F-SERIES DRIVESHAFT INSPECTION

AFFECTED VEHICLES: **CERTAIN 2000 AND 2001 F-250 AND F-350 4X4 SRW MODELS EQUIPPED WITH GAS ENGINES AND 5-SPEED MANUAL TRANSMISSIONS**

FIGURE 1

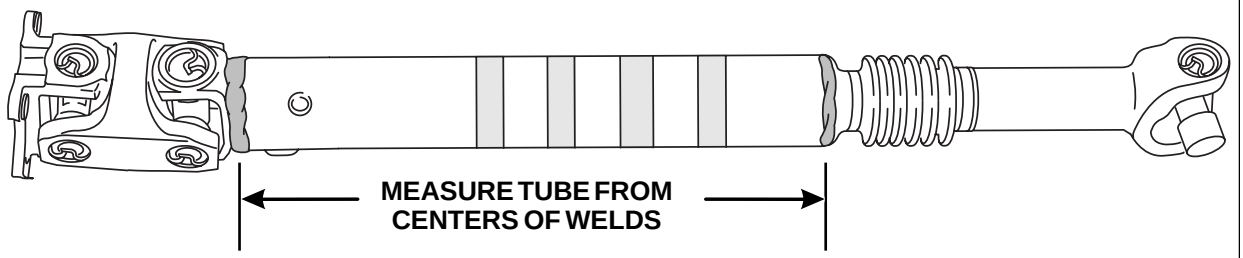
1. Raise and support the vehicle on a hoist.
2. Inspect to see if the entire front driveshaft is painted black. If necessary, wipe it clean.
3. If the driveshaft is black, no service is required. Lower and release the vehicle.
4. If the driveshaft is not painted black, measure the length of the tube from the centers of the welds. See Figure 1.

5. If the driveshaft tube measures less than 524 mm (20 5/8 inches), no service is required. Lower and release the vehicle.
6. If the driveshaft tube measures 524 mm (20 5/8 inches) or greater, the drive shaft must be replaced. Refer to Section 205-01 of the appropriate workshop manual for replacement instructions.
